STATE OF NORTH CAROLINA  
DEPARTMENT OF TRANSPORTATION

Subject: **Response to US Army Corps of Engineers Letter** for the proposed NC 133 Connector from NC 211-133 (Southport Supply Road) to NC 87-133 (River Road), Brunswick County, TIP R-3324.

References: Application for an Individual Section 401 Water Quality Certification dated July 19, 2012  
USACE Request for Additional Information Letter dated, September 18, 2012 (received September 24, 2012).  
NCDOT Response to US Army Corps of Engineers Letter dated, October 18, 2012.

# SITE V

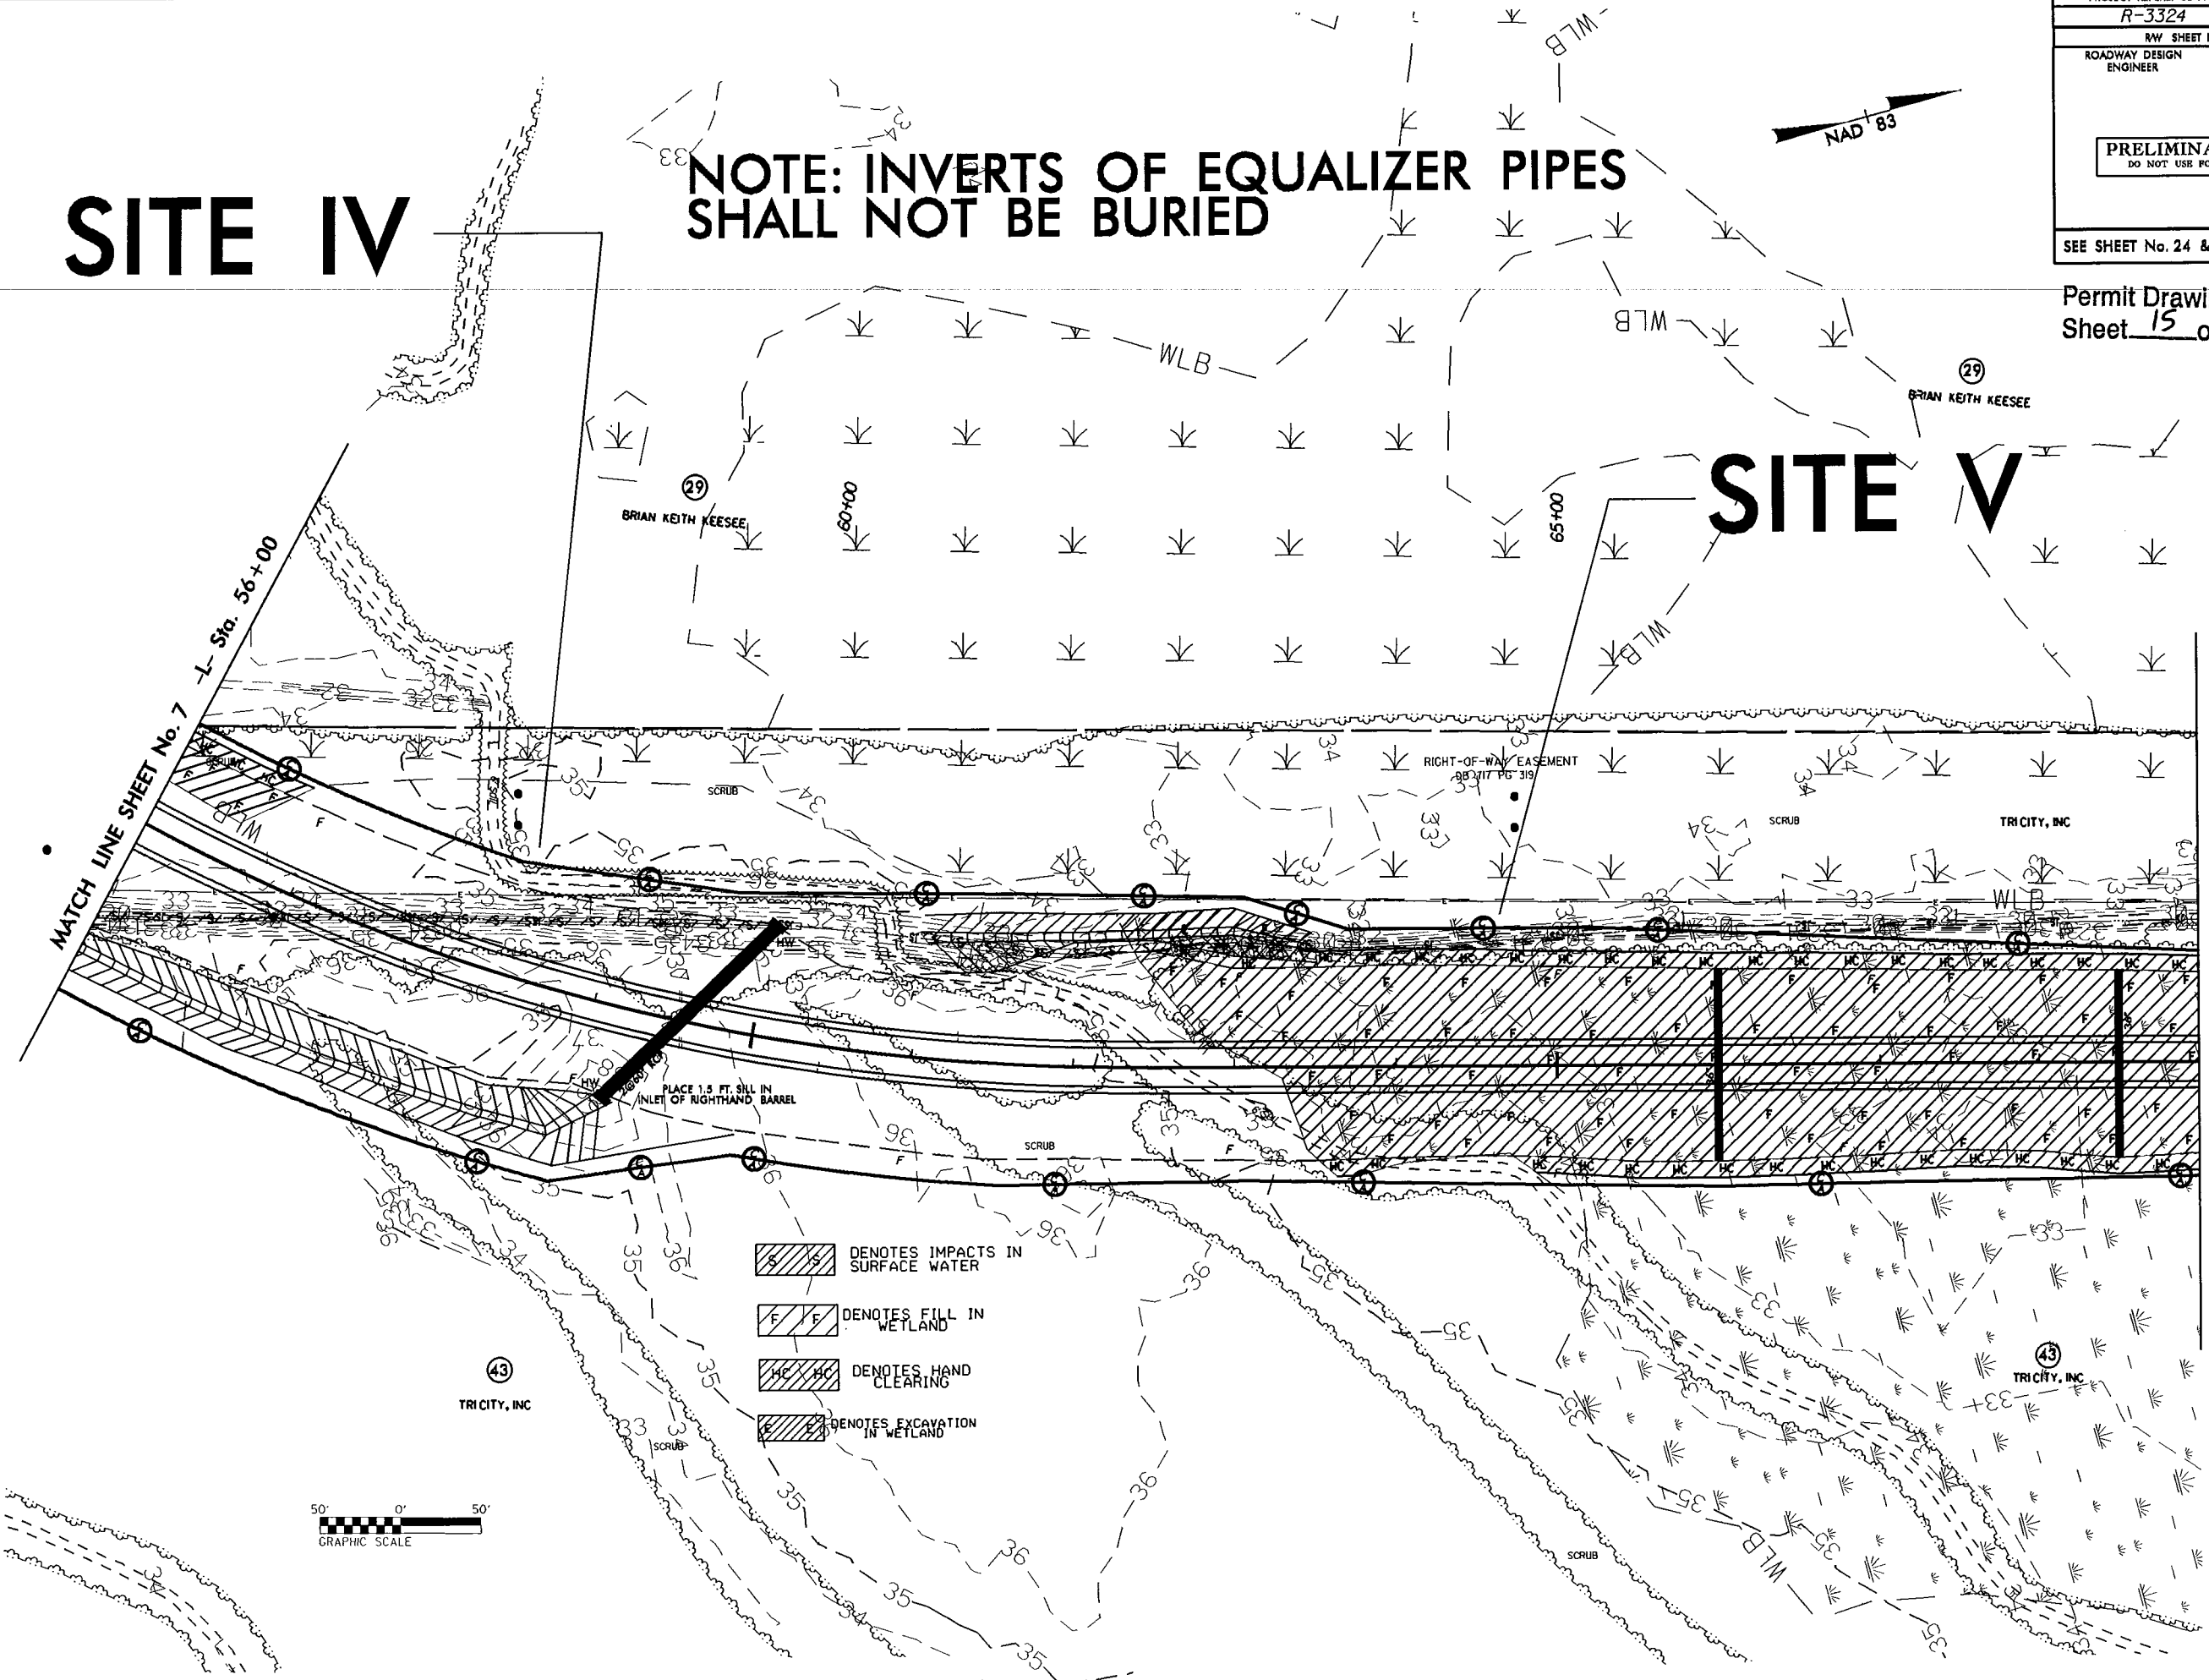
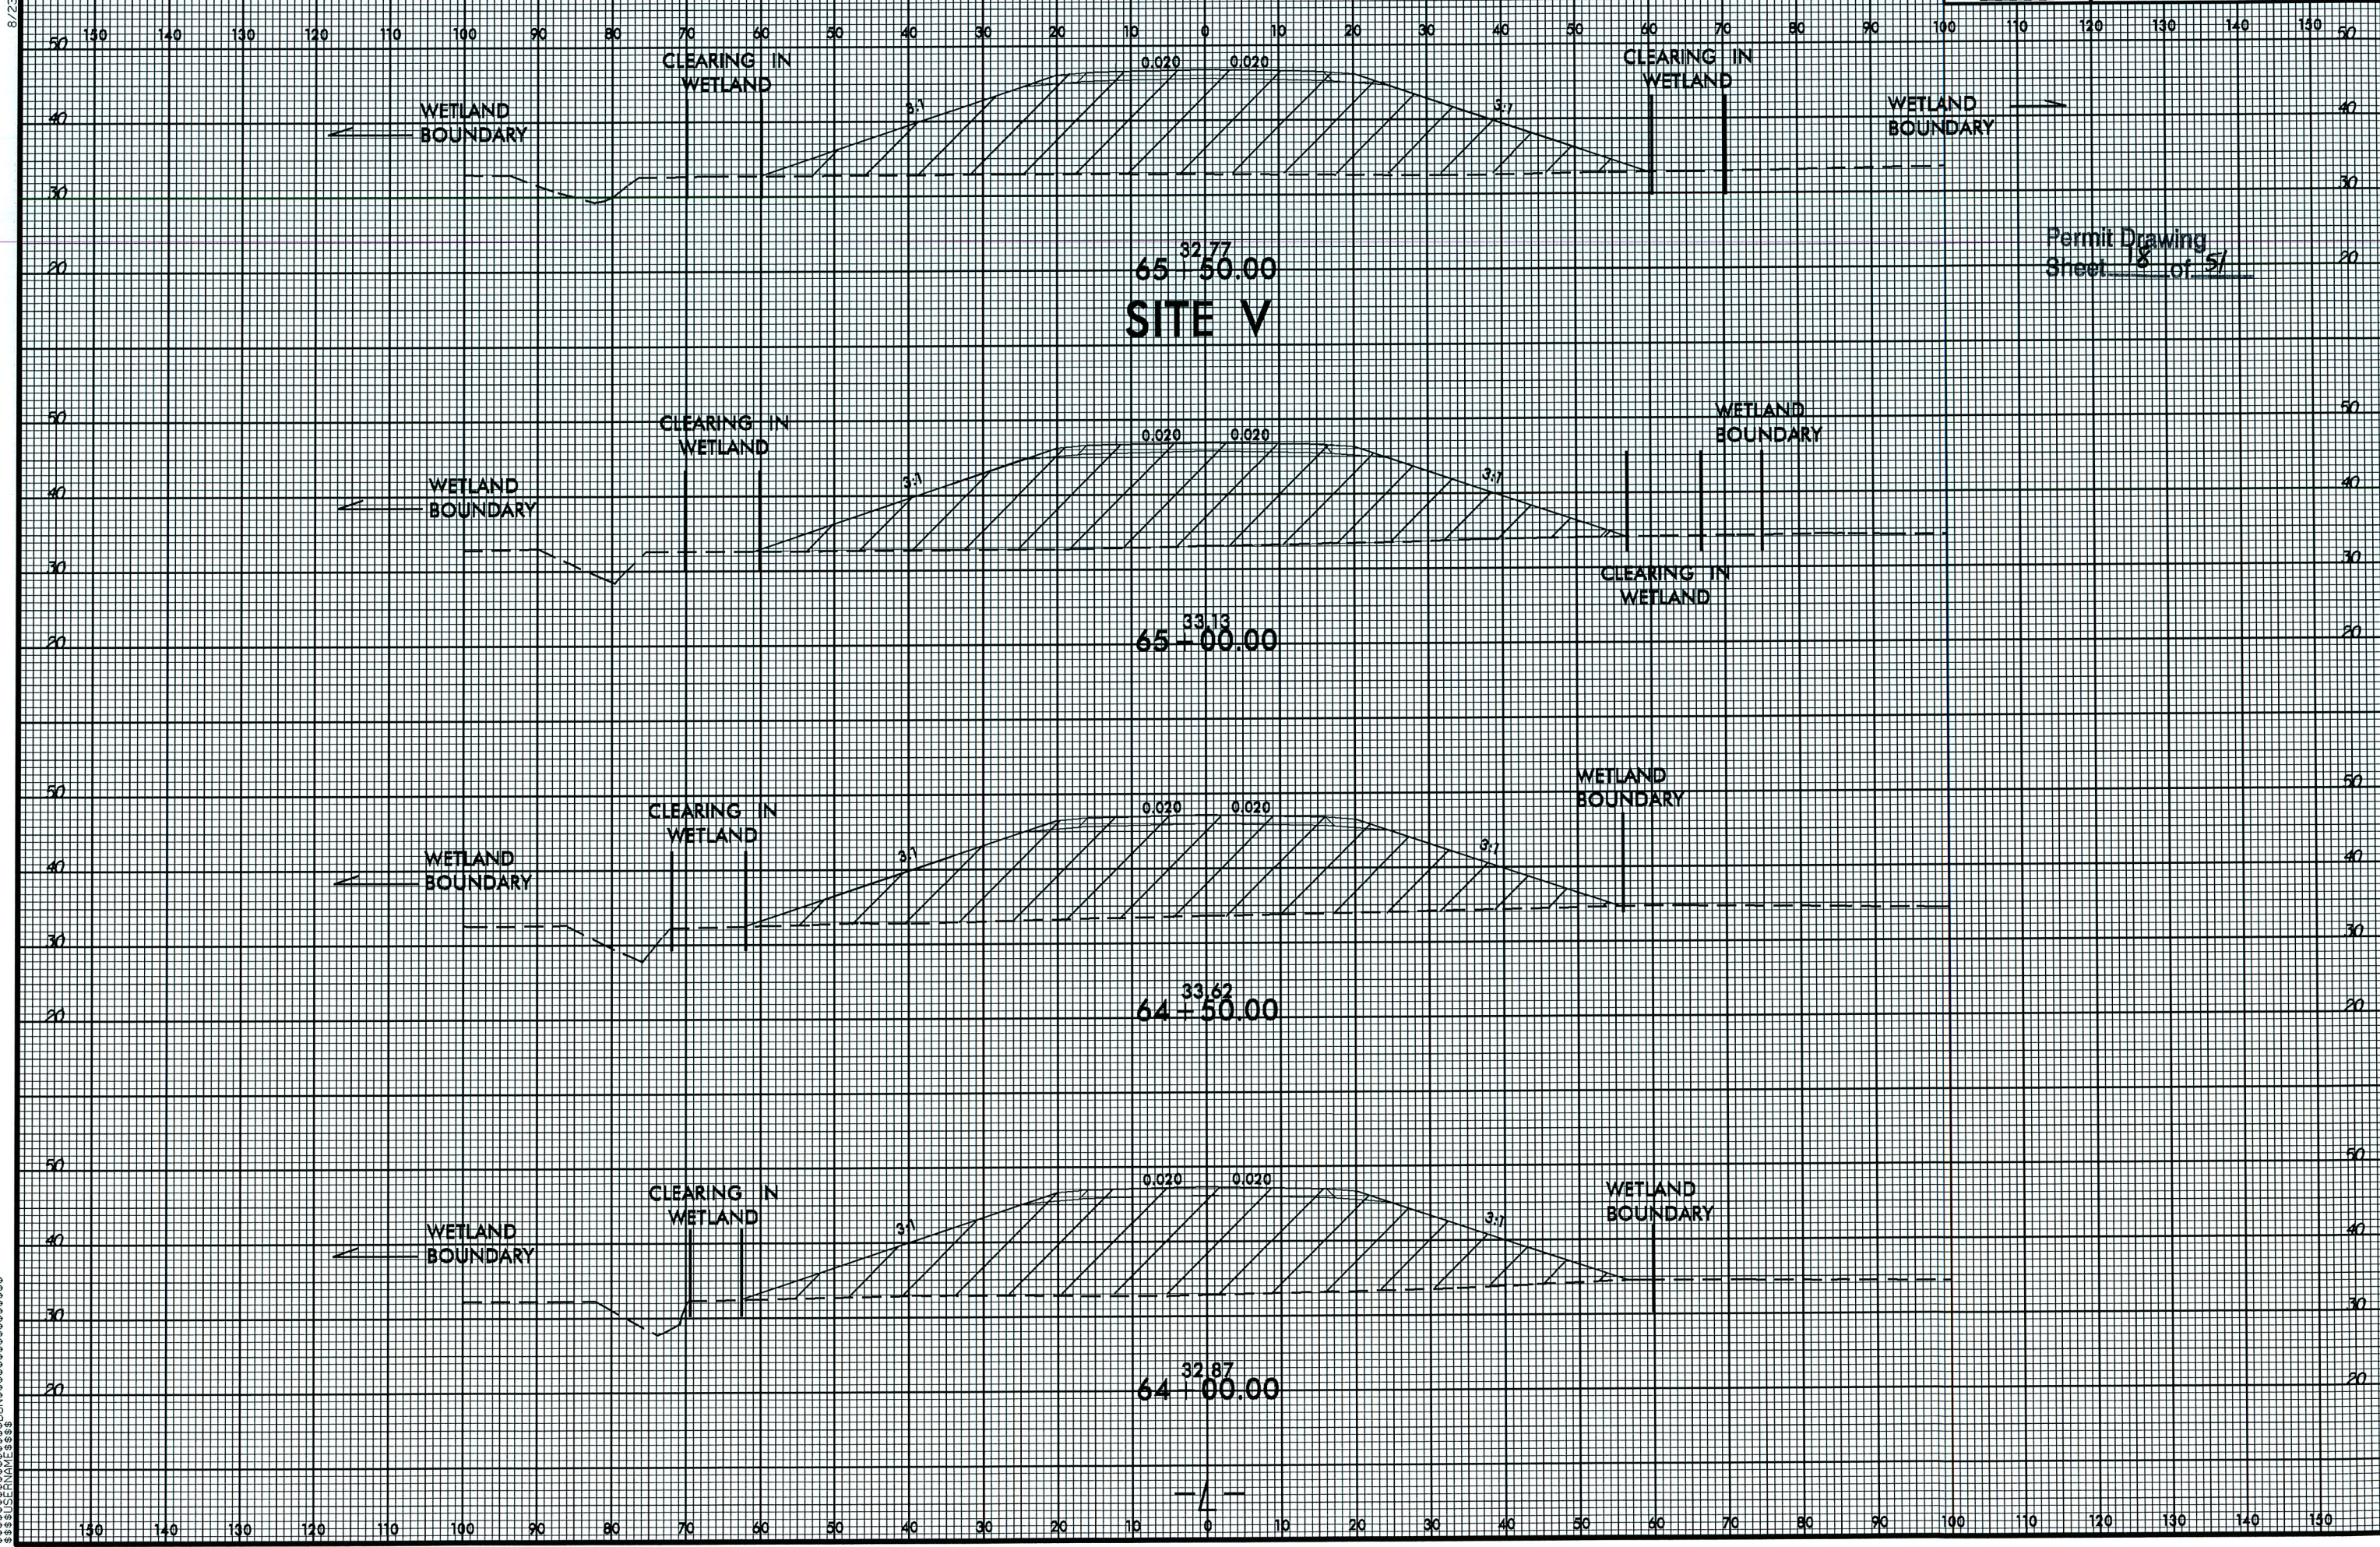
4. Site 5: *Notes equalizer pipes but does not show them in cross section drawings indicating burial or not, please clarify.*

Response provided in previous correspondence.
